Report: TAB Report
Function: Test, Adjust, & Balance
Date: 06/07/2024

PROJECT

06-03-24 WAWA #8187 TANNERSVILLE, PA

image
06/05/2024

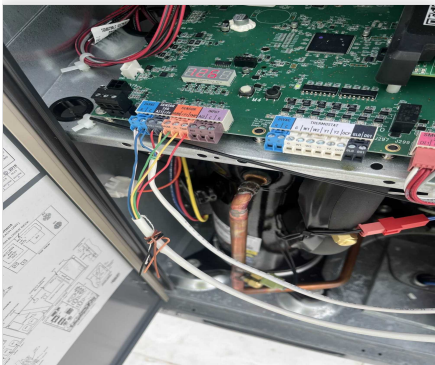
Issue Name : EF Securement
Description : The EFs are not secured to the curbs. Recommend securing to the curbs with proper fasteners. (Applies to all Exhaust fans)
Created By : National TAB **Assigned To :** National TAB - Tyler Youells
Status : Open
Priority : Medium **Asset Tag :**
Originated Date : 06/05/2024 - Tyler Youells - National TAB

IMG_6803
06/05/2024

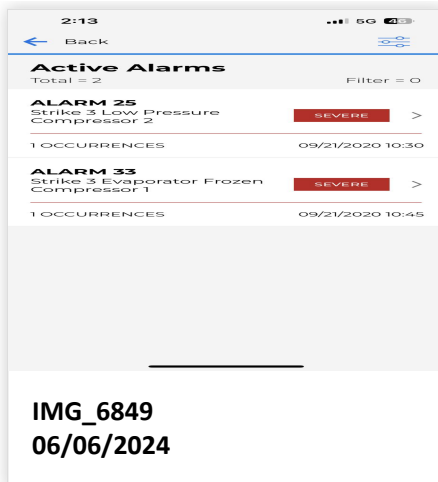
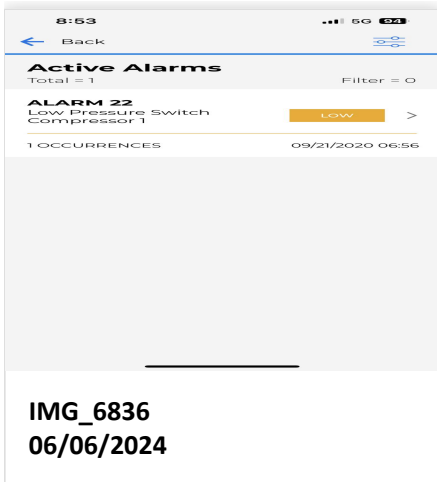
Issue Name : RTU Sensor Wiring
Description : RTU sensor wiring is not run per manufacturers specifications. Typical thermostat wiring was used. Spec calls for separate sets of two wire shielded for the humidity sensor and temperature sensor. Recommend replacing wire to ensure sensor will read correctly preventing any space comfort issues.

IMG_6802
06/05/2024

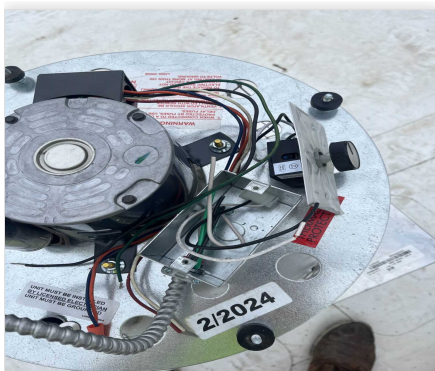
Issue Name : RTU-3 Power exhaust Kit
Description : The factory shipping cover is installed on RTU-3 power exhaust. Cover needs to be removed and backdraft louvers installed for proper function and operation of the power exhaust. Recommend contacting Lennox if Backdraft louvers cannot be located. Not TAB Critical
Created By : National TAB **Assigned To :** National TAB - Tyler Youells
Status : Open
Priority : High **Asset Tag :**
Originated Date : 06/05/2024 - Tyler Youells - National TAB

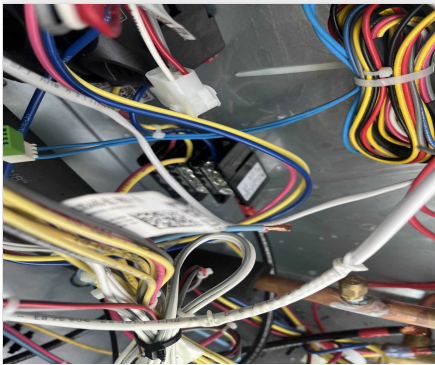
Issue Name : RTU-1/2 Phasing issue
Description : RTU-1/2 both have a phase error alarm preventing the units from running. Electrician to swap phases and resolve.
Created By : National TAB **Assigned To :** National TAB - Tyler Youells
Status : Closed
Priority : Urgent **Asset Tag :**
Originated Date : 06/05/2024 - Tyler Youells - National TAB

- **06/05/2024 National TAB - Tyler Youells**
 - Electrician has resolved phasing issues and both units are now running.
